SMALL ARROW ENGINEERING, LLC

EMW Public Access CNG Station Moriarty, New Mexico Addendum Number 1

Date: September 2, 2020
Issued to: All Bid Document Holders of Record

SURVEY BY: N/A PROJECT #: 20104
 DRAWN BY: TED DATE: 08/12/2020
 CHECKED BY: JHB SCALE: 1"=10'
 PROJECT: PUBLIC CNG STATION
 SHEET DESC: CANOPY LAYOUT & ELEVS
 SHEET: 8 OF: 27

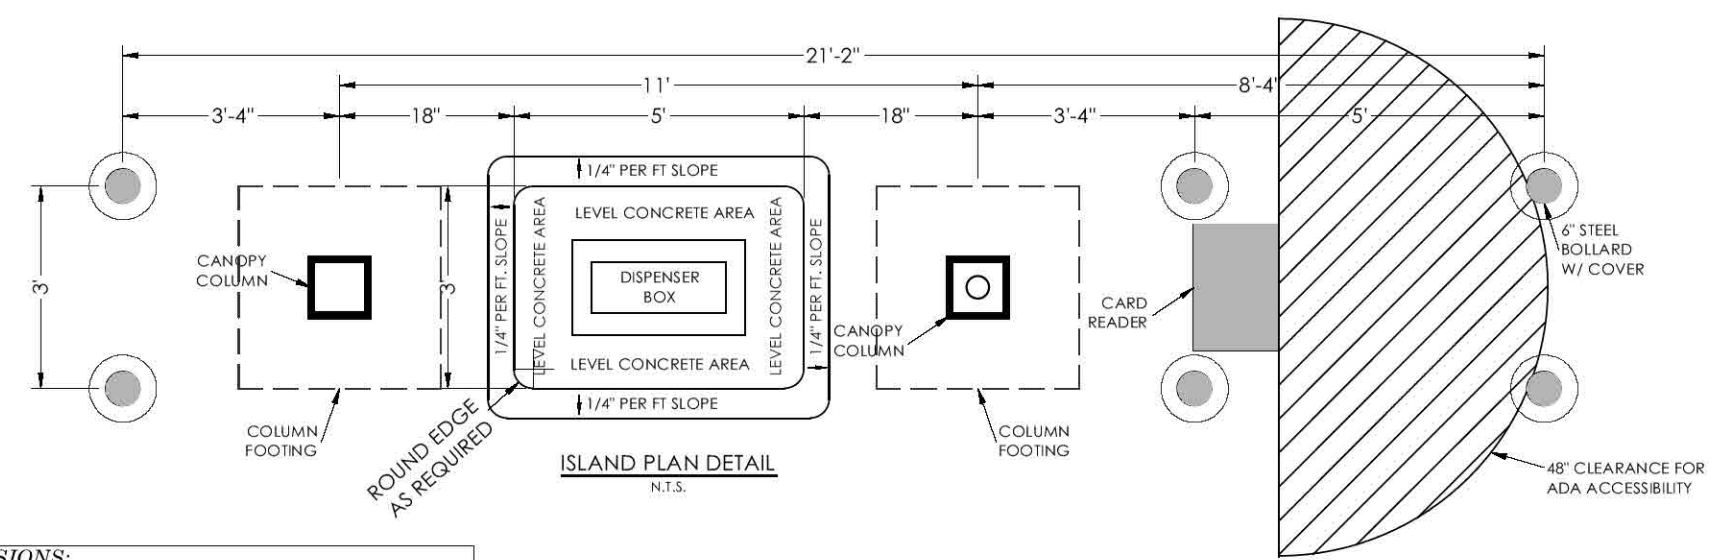
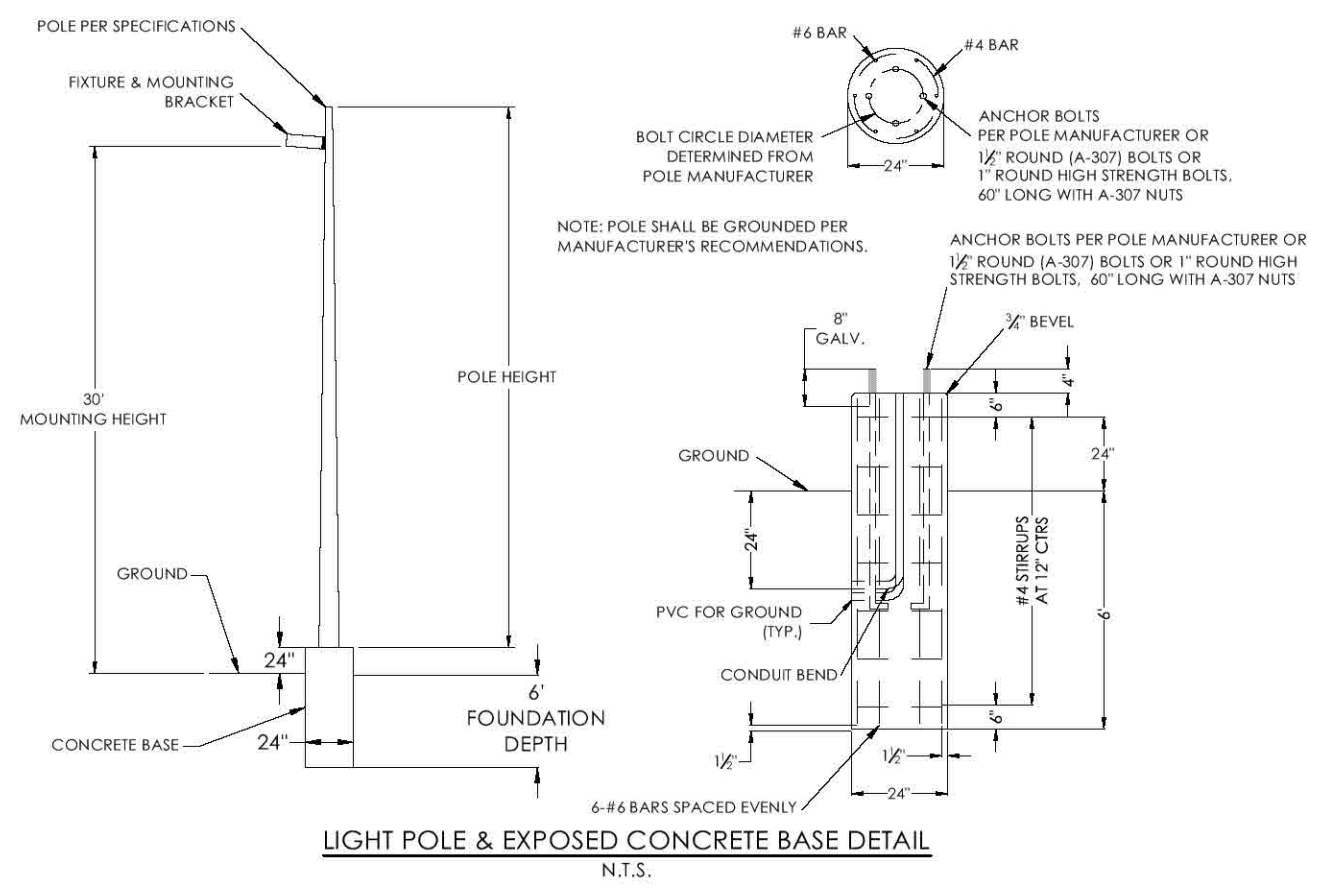
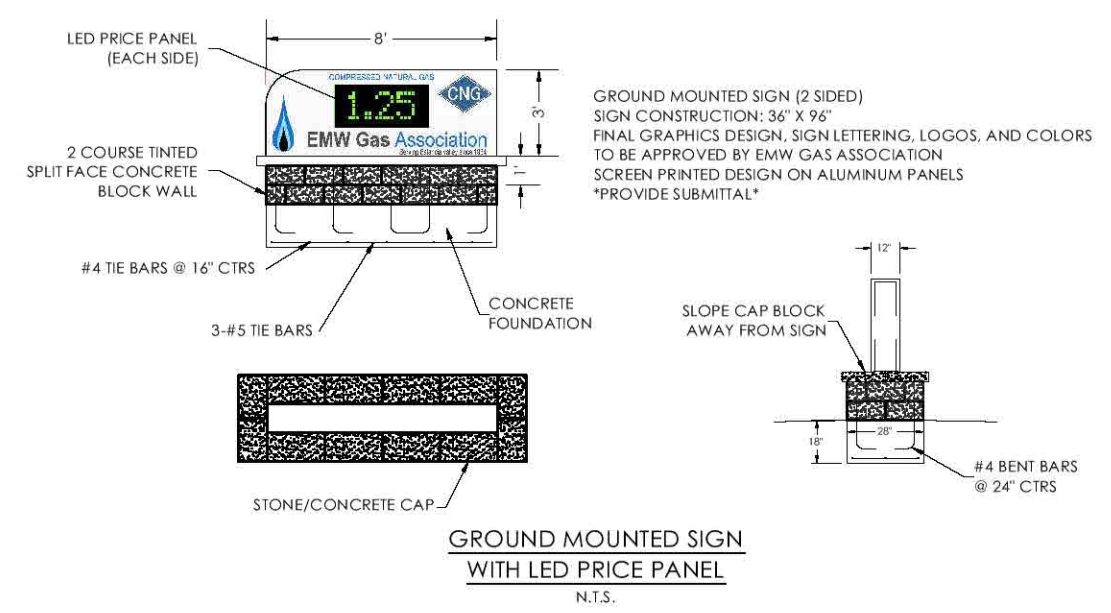
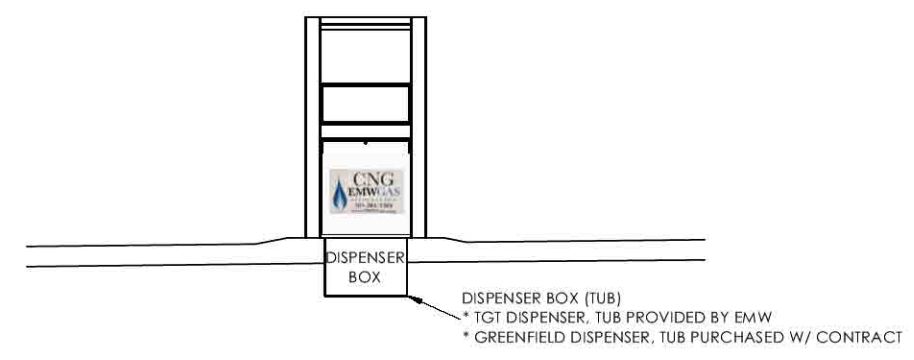
1. Is there a light pole base detail? **A detail has been added to Sheet 8.**

REVISIONS:
 1 9-1-20 ADDED LIGHT POLE & BASE DETAIL

ASPHALT PAVEMENT SECTION DETAIL
N.T.S.

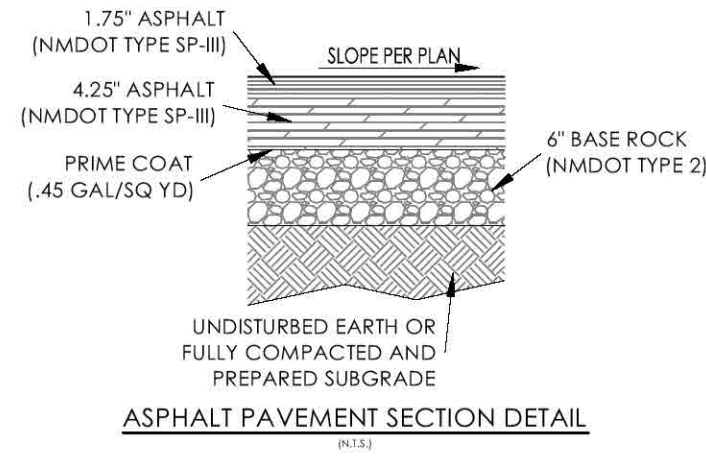
1. **12" Thick Chip and Seal paving has been replaced with 6" SP-III Asphalt over 6" NMDOT Type 2 Base. (See detail Sheet 10 of Plans).**

2. Please provide details for the chip and seal (w/12" base). If asphalt is acceptable as an alternate, please provide details. **Yes, Asphalt will be acceptable. We have replaced the Chip & Seal option with Asphalt. There is now a detail on Sheet 10. There is also an alternate bid item added to the Bid Form for using all asphalt paving except the concrete fueling pad under the canopy.**

CONCRETE PAVEMENT SECTION DETAIL
N.T.S.

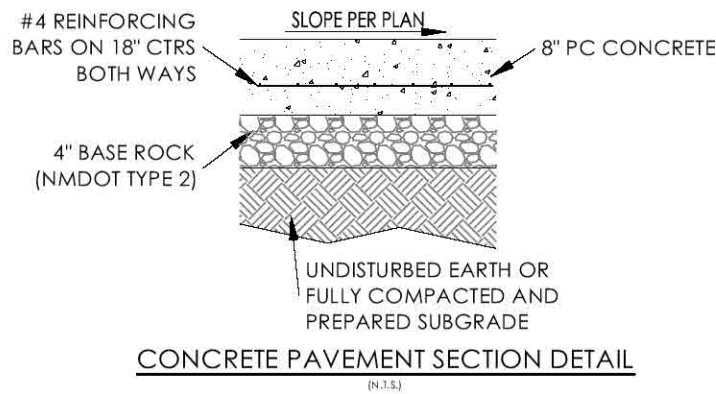
3. Please provide details for 8" HD concrete paving. **There is now a detail on Sheet 10.**
4. Is the NMDOT permit and its requirements relating to the concrete entrance available? **Not at this time.** Please provide copy of the NMDOT permit drawings referred to on sheet 2? **Use typical sections now available on Sheet 10.** Unit price sheet lists details #13,15,16 & 31 referring to NMDOT not shown on plans? **Use details on Sheet 10, Refer to NMDOT Standard Specifications for gradations. Also, please refer to NMDOT Standard Drawing 702-05-1/1 "INSIDE / MEDIAN AND OUTSIDE LANE OPERATIONS FOR DIVIDED INTERSTATES & NON-INTERSTATES" for traffic control measures required for lane closure along Business Loop 40.**

REVISIONS:
1 9-1-20 REVISED GRAVEL DETAILS, ADDED PAVEMENT TYPICAL SECTIONS FOR CONCRETE AND ASPHALT

PROTECTIVE TUBING HOUSING DETAIL
N.T.S.

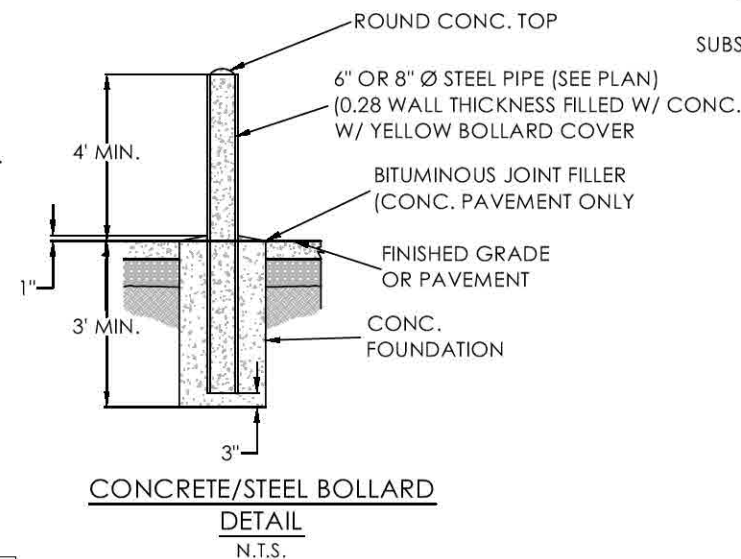
1. Unit price sheet item #54- Protective hat over exposed tubing/conduits, details? Is this Detail on Sheet 10? **Yes, that is the detail.**
